**Subject:** EPA Comments on GHG/CAFE NPRM Preamble

Consistent with the discussion earlier this week, attached are EPA's comments on the preamble. These primarily focus on the flexibilities section but there are comments on other parts of the preamble, many of which reflect issues we have already raised.

2021-2026 Model Year Corporate Average Fuel Economy Standards and Light-Duty  
Vehicle Greenhouse Gas Emissions Standards

**Figure II-4 - Fatalities per million registered vehicles, 1996 -2015**

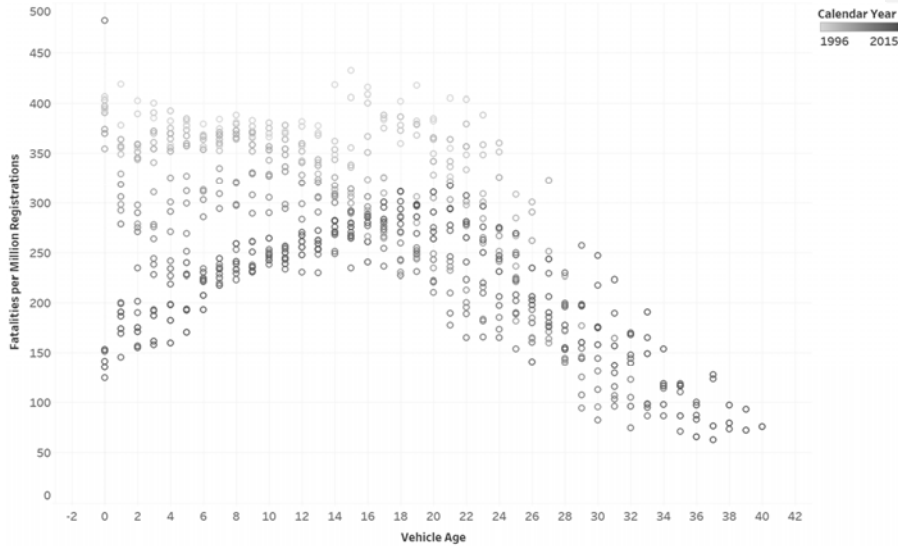
**Commented [A57]:** From this figure, it seems fatalities are almost a constant for first 15 years then decline as the vehicle is getting older as measured as fatalities per million VRY. This contradicts what NHTSA claims here: that new vehicles have less fatalities.
